PERMIT APPLICATION FOR INLAND WETLANDS & WATERCOURSES
ACTIVITY: (check one of the following)

Date: February 16, 2017 (Revised May 30, 2017)
To: Planning & Zoning Commission
From: Darin Lemire, PE
Freeman Companies, LLC
Subject: Drainage Memorandum
178 Westmont
West Hartford, Connecticut

From: Todd Dumais [<mailto:Todd.Dumais@WestHartfordCT.gov>]
Sent: Wednesday, May 17, 2017 10:36 AM
To: 'leoneconstruction@gmail.com'
Cc: Catherine Dorau <cdorau@WestHartfordCT.gov>; 'REMA8@aol.com' <REMA8@aol.com>; Darin Lemire <dlemire@freemancos.com>; Duane Martin <DuaneM@WestHartfordCT.gov>
Subject: 178 Westmont - Supplemental Information - Planning Division Comments

Subject: Response to Comments
178 Westmont
Inland Wetlands and Watercourses Application No. 1063
West Hartford, Connecticut

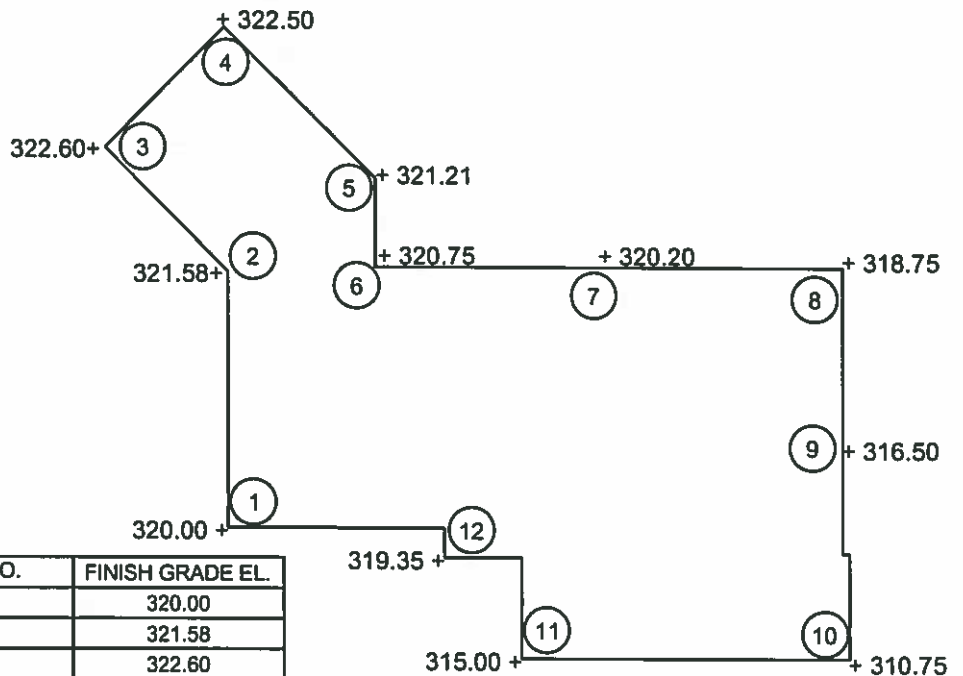
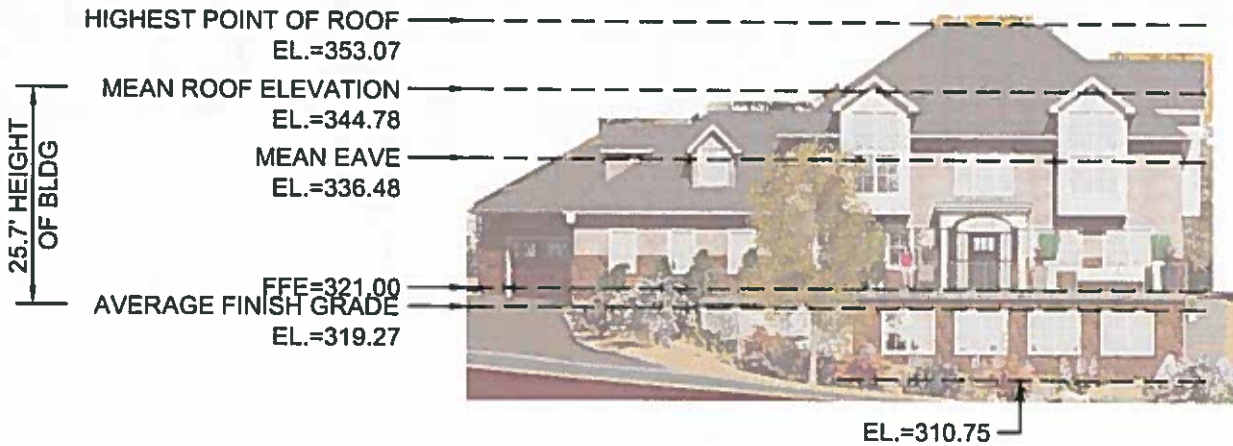
6. Previous Planning Comment: Building height calculation for the proposed house has yet to be submitted. (Note a proper height calculation methodology was previously forwarded in a 2.23.17 email). **See attached building height calculation. The Grading and Drainage drawing was revised at northeast building corner to show the revised spot grade 310.75' and zoning table was revised for building height.**

7. General Comment: Please update the plan to include the finished basement floor elevation for the proposed home.
The basement floor will be 10 feet 3 inches lower than the 1st floor finished floor elevation (FFE).
